MEETING AGENDA

Appearance Commission

Village of Homewood

July 06, 2023

TITLE:
LANDSCAPE PLAN

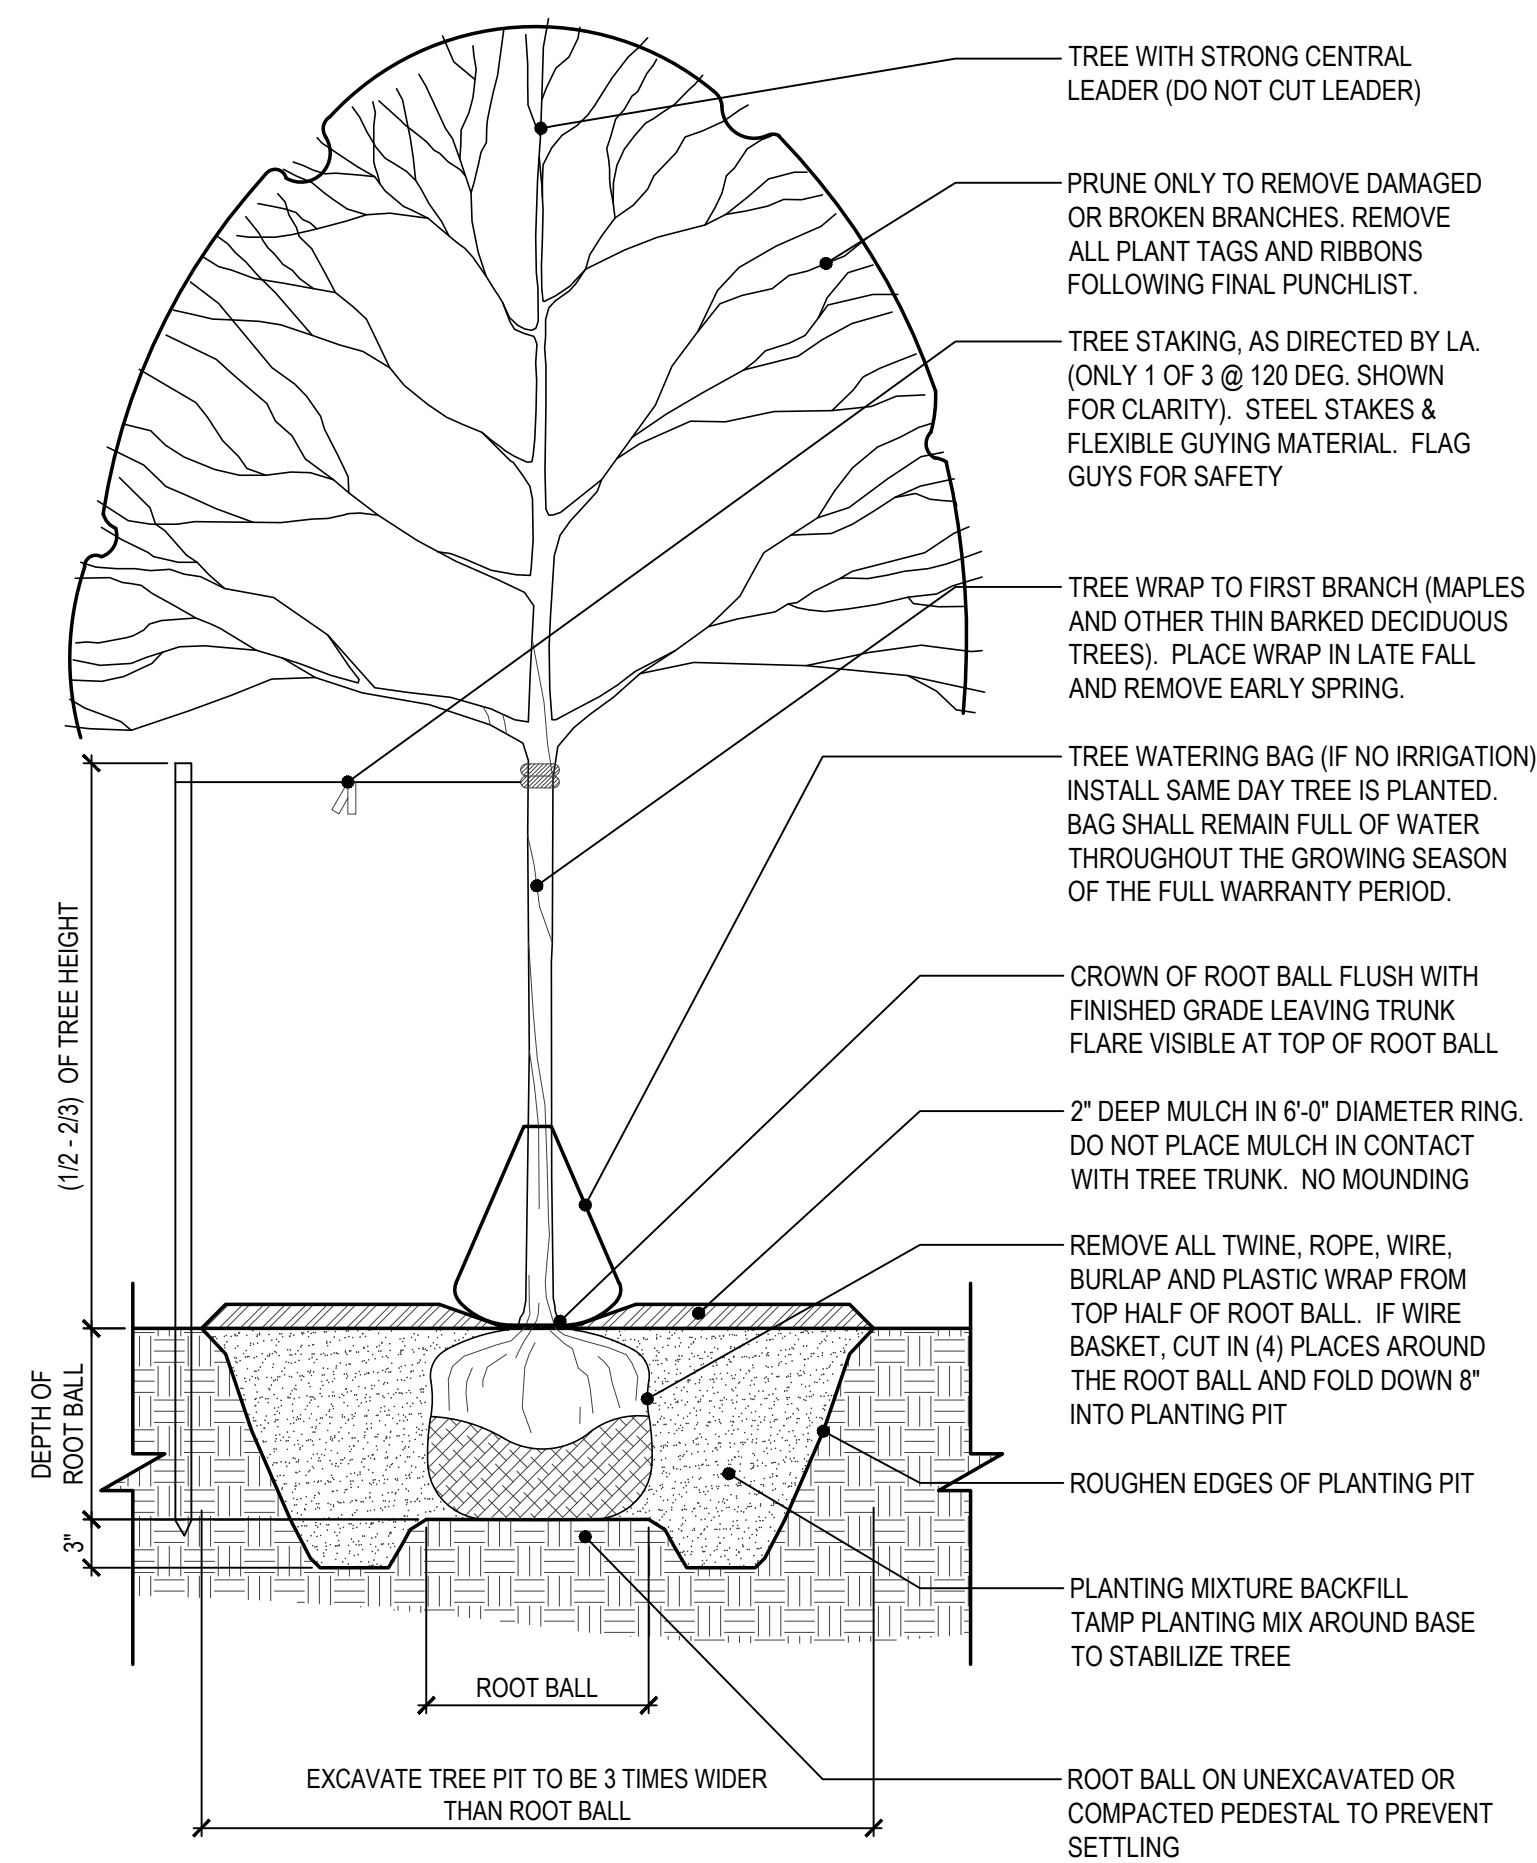
-
1. Halsted requirements are met
 2. Swap out Arctic Dogwoods for Smooth Hydrangea
 3. Extra focus to contractor regarding L201 figure 1 tree planting. Leave trunk flare visible. Planting grade is a trunk flare, excavate root ball if necessary to find
 4. Notes 5.1 = and follow ANSI A300, Z133.1 and Z60.1

Proposed changes to storefront windows

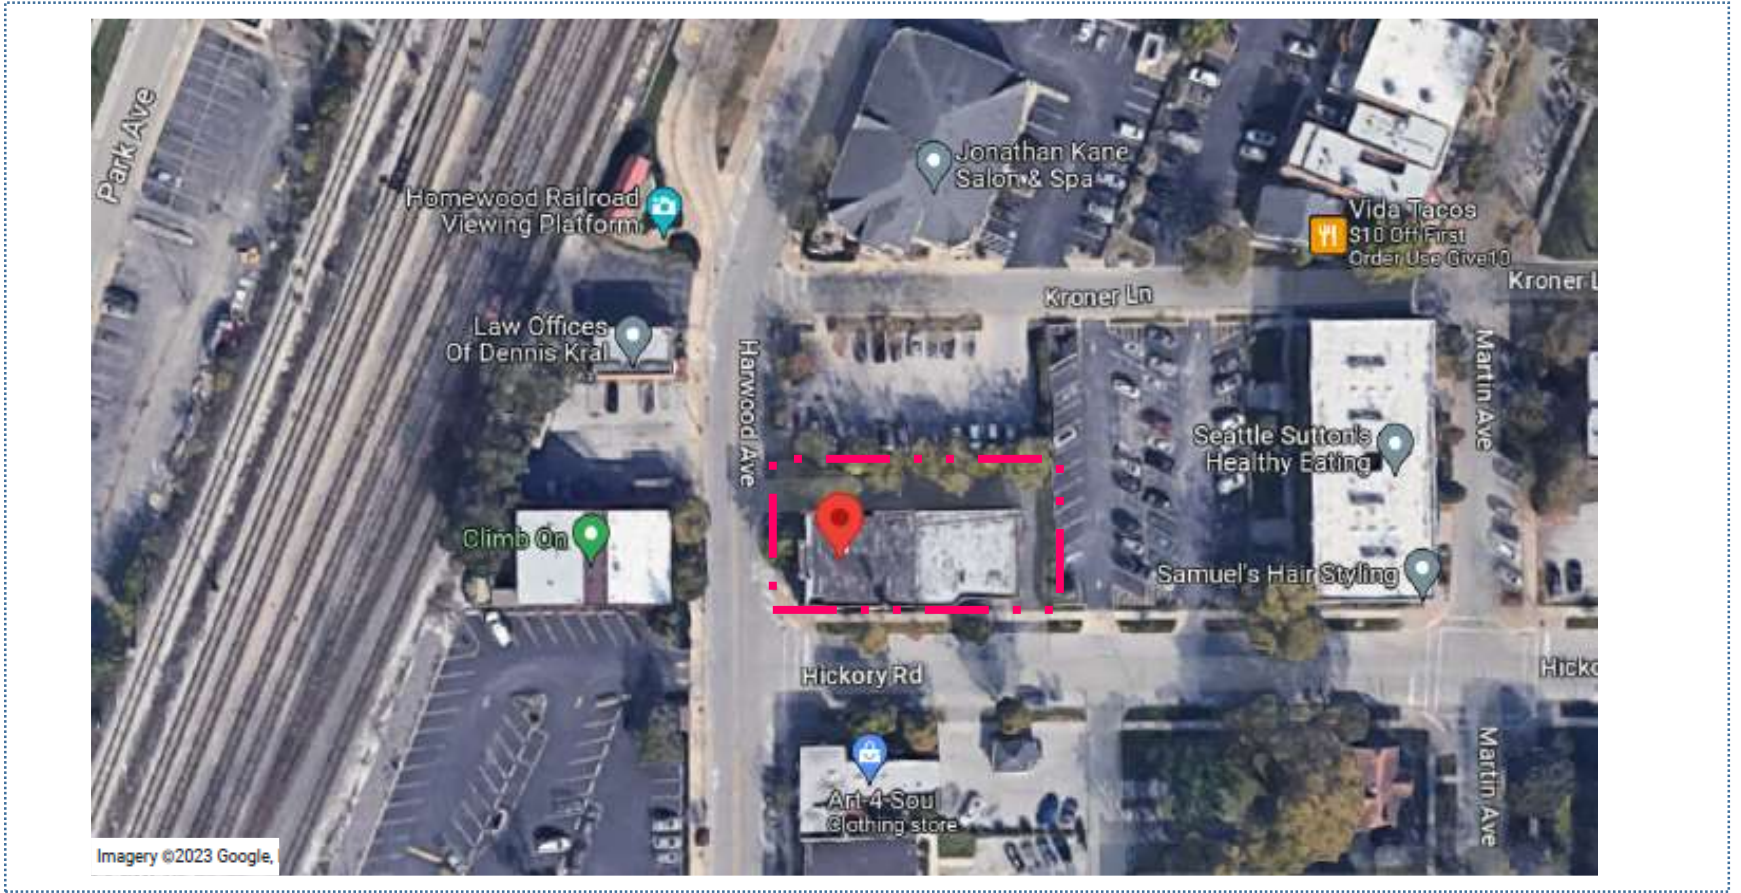
- Police Chief: questions about the placement of surveillance cameras (interior and exterior)
- Public Works: One concern is how the salt from the sidewalk & snow removal might damage the framing of the windows if the frame goes to the sidewalk at grade level.
- Public Works: Would there be any protection for the glass, from a sidewalk snow plow? Any sliding of the machine on the sidewalk could cause the plow blade to hit the glass window.
- Fire Chief: no concerns.
